QUAD CITIES NUCLEAR POWER STATION, UNIT 1

AMENDMENT TO FACILITY OPERATING LICENSE

Amendment No. 83
License No. DPR-29

SUPPORTING AMENDMENT NO. 83 TO FACILITY LICENSE NO. DPR-29

Fig. 3.5-1
(Sheet 1 of 4)

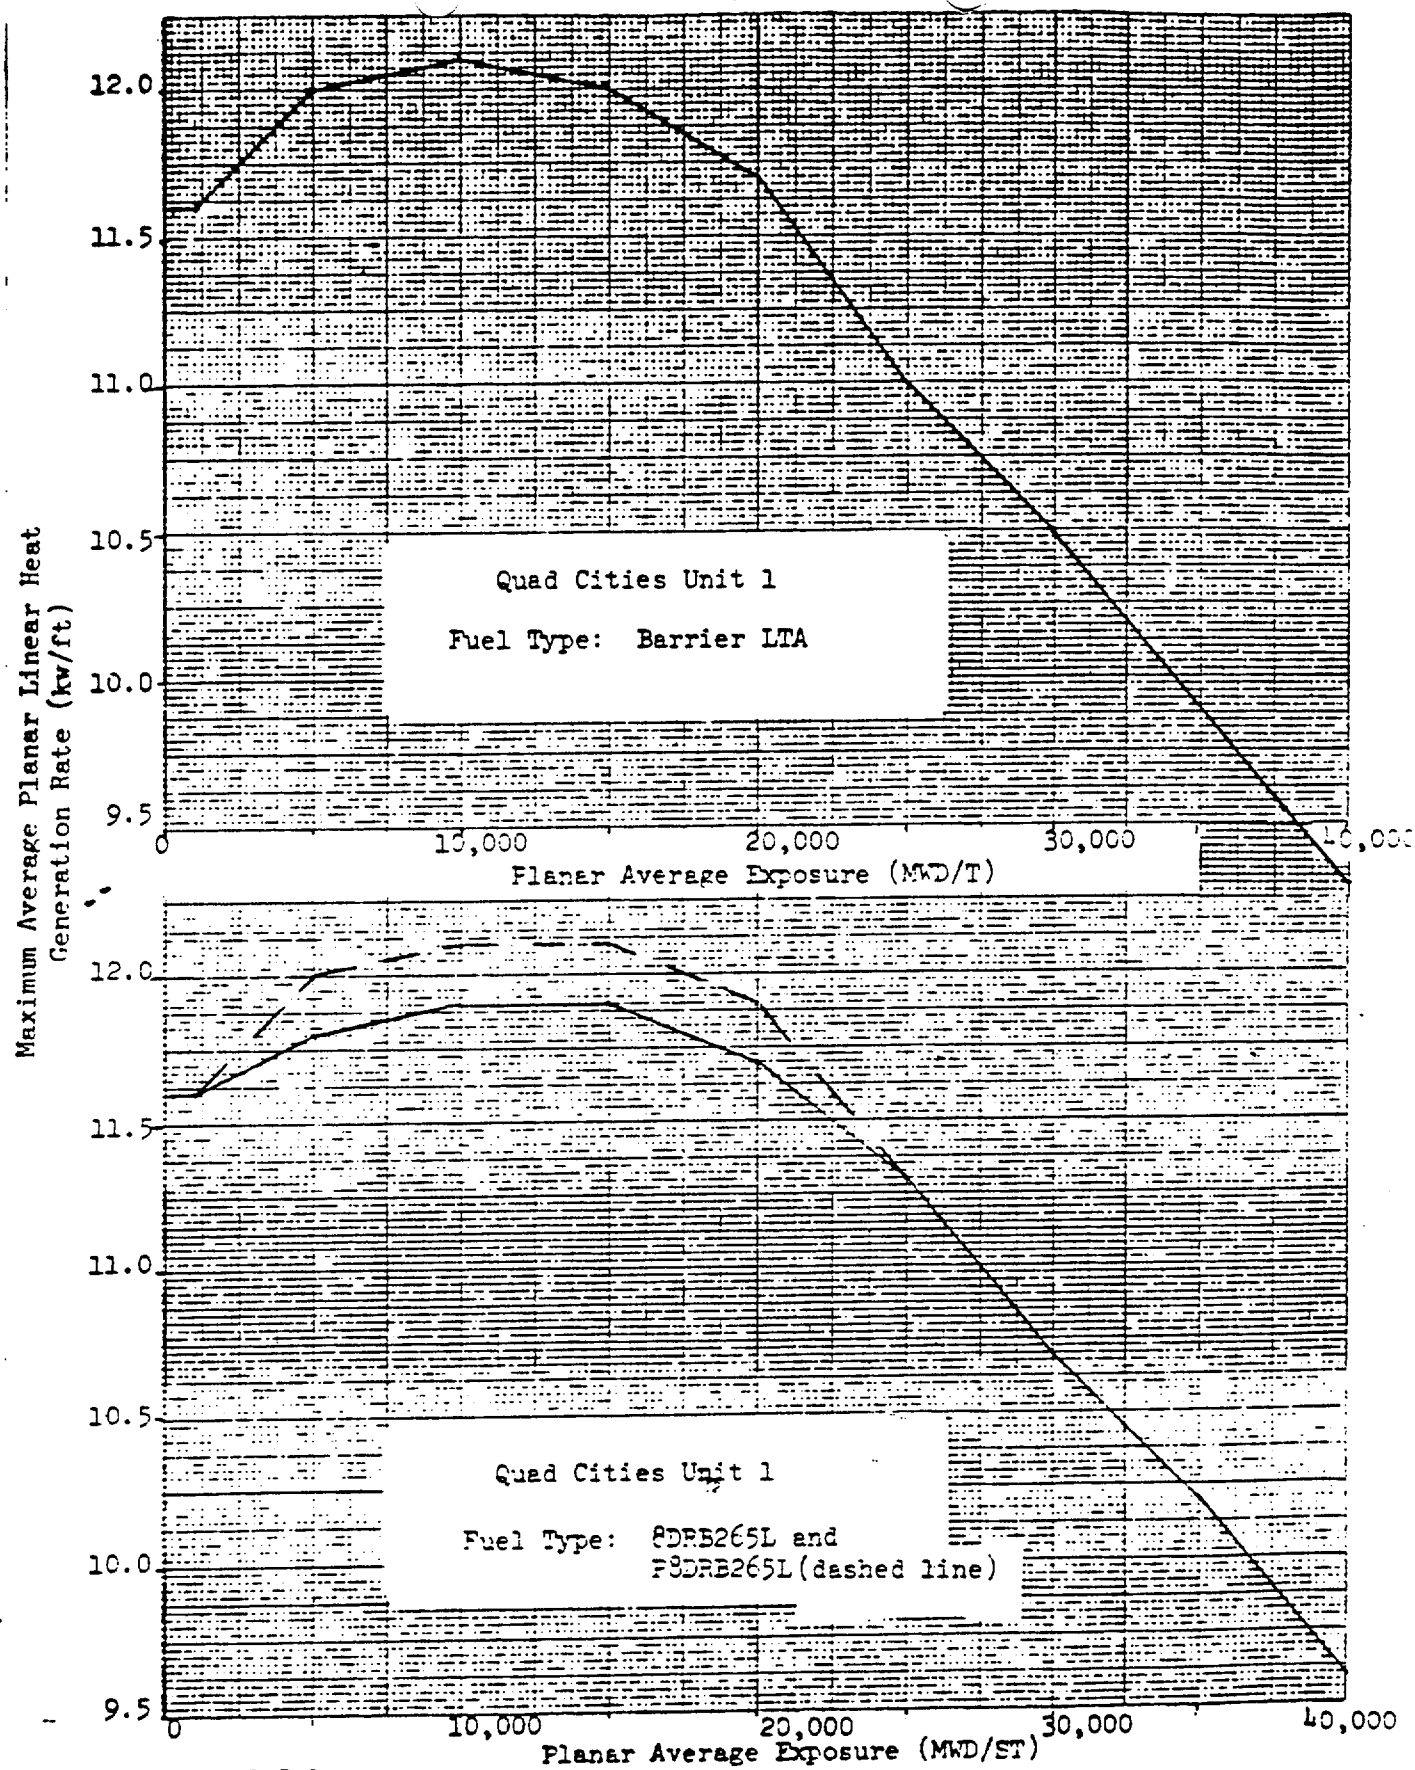
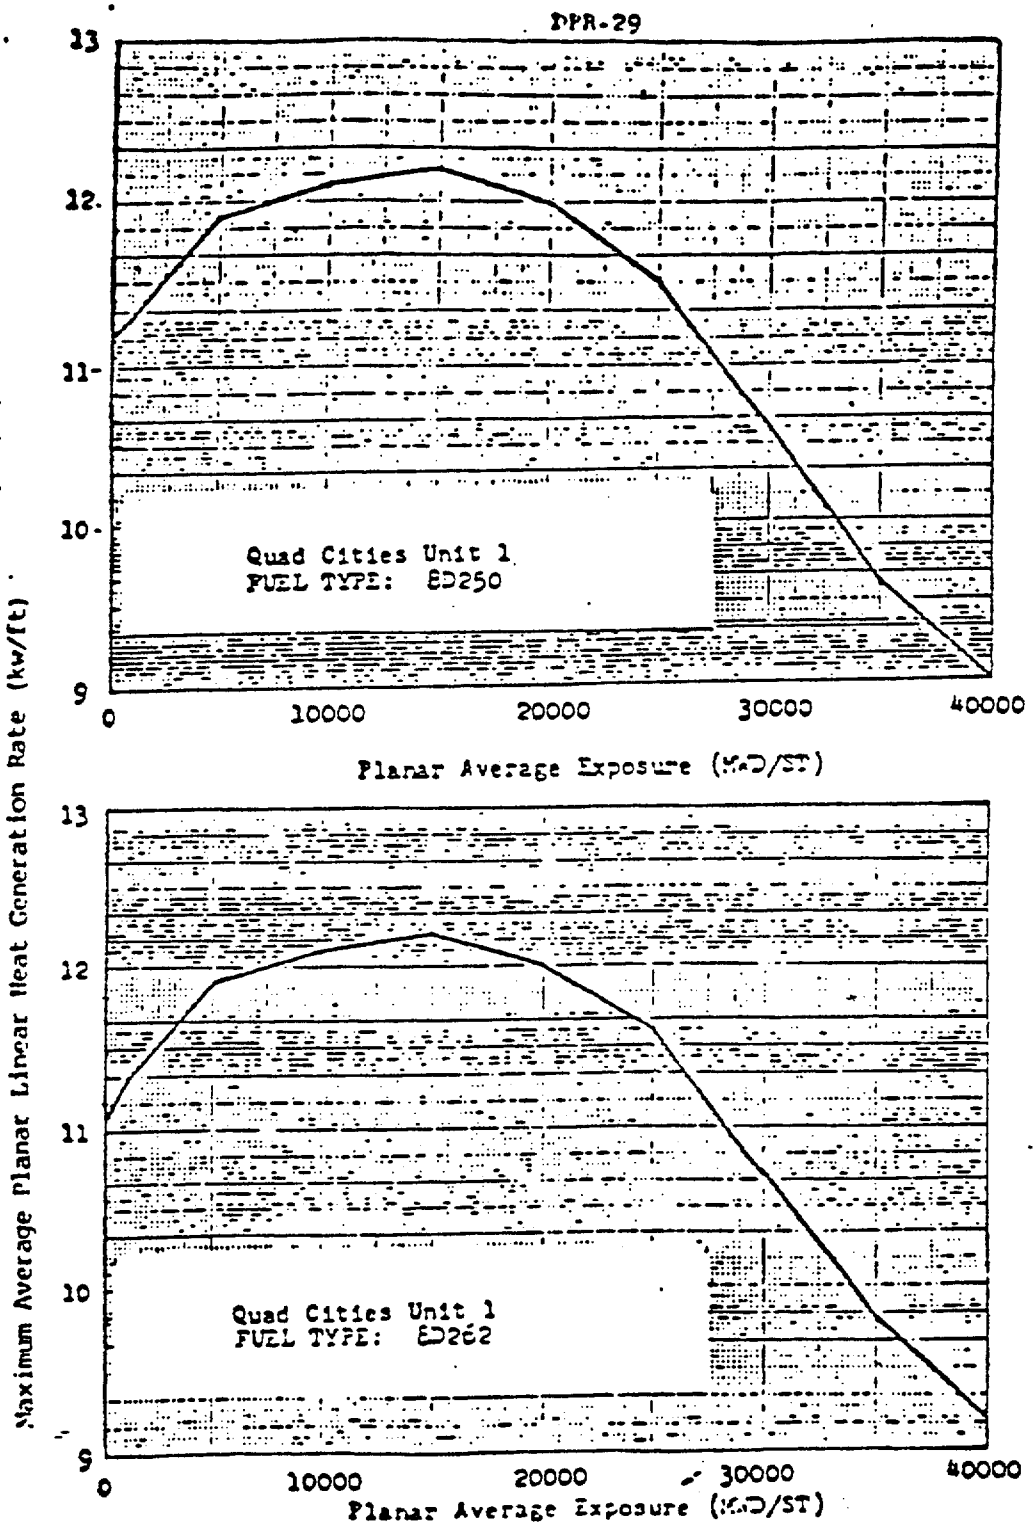
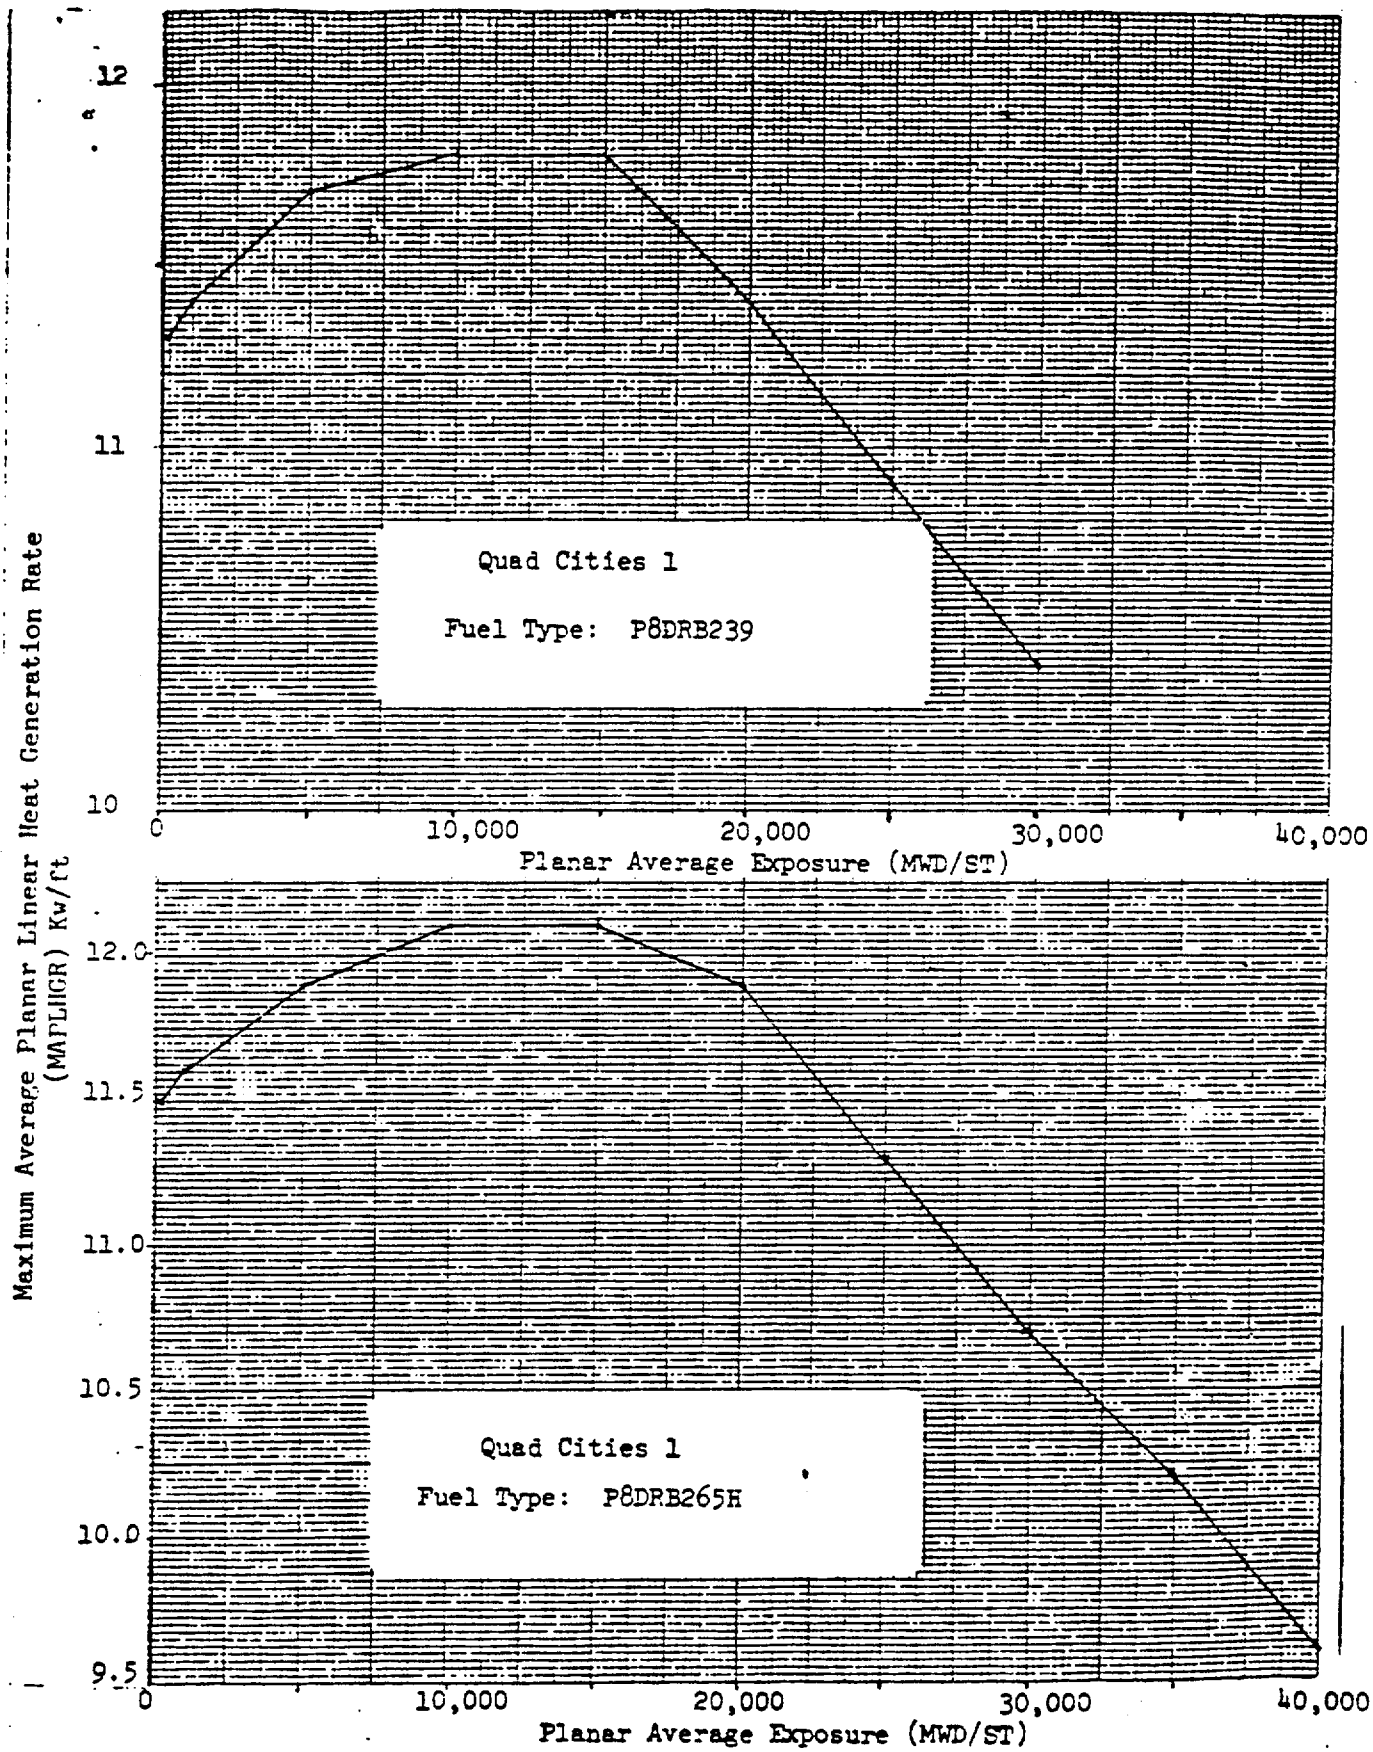
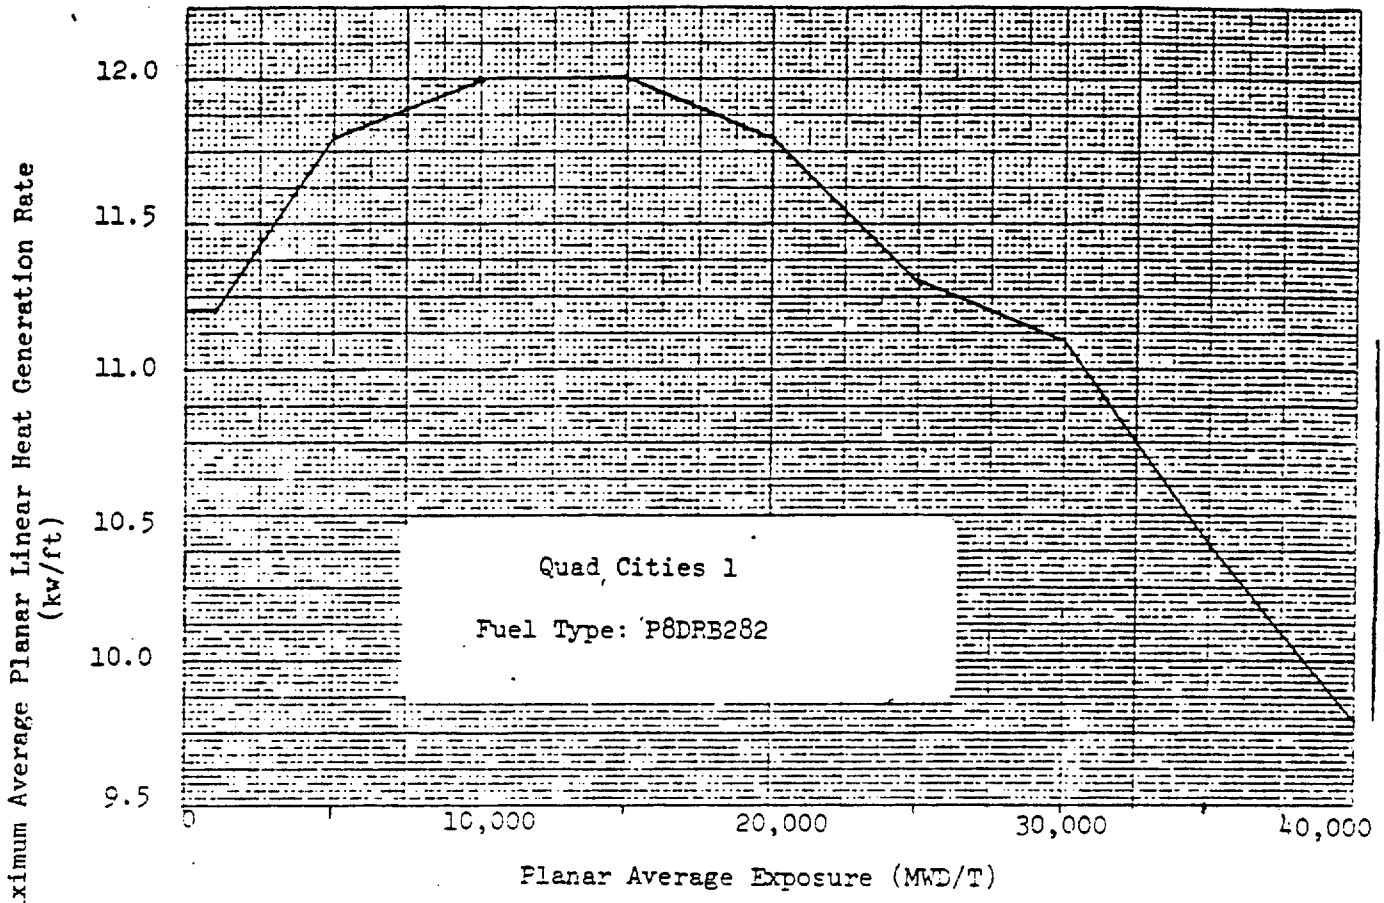
The licensee has proposed TS changes that will revise the MAPLHGR limit curves for fuel types 8DRB265L, P8DRB265L, P8DRB265H and P8DRB282. For all the fuel types mentioned, the revised curves extend the MAPLHGR limits from the previous maximum planar average exposure of 30,000 MWD/ST to a planar average exposure of 40,000 MWD/ST. MAPLHGR limits to nonprepressurized fuel have previously been conservatively applied to prepressurized

fuel because of the unavailablity of the slightly less restrictive MAPLHGR limits for prepressurized fuels. These limits for prepressurized fuel are now available and are incorporated in the revised TS for upcoming operating Cycle 7. We previously approved the extension of MAPLHGR curves to fuel exposures of 40,000 MWD/ST for all fuel types cited here (see Reference 4) and therefore, find this acceptable.
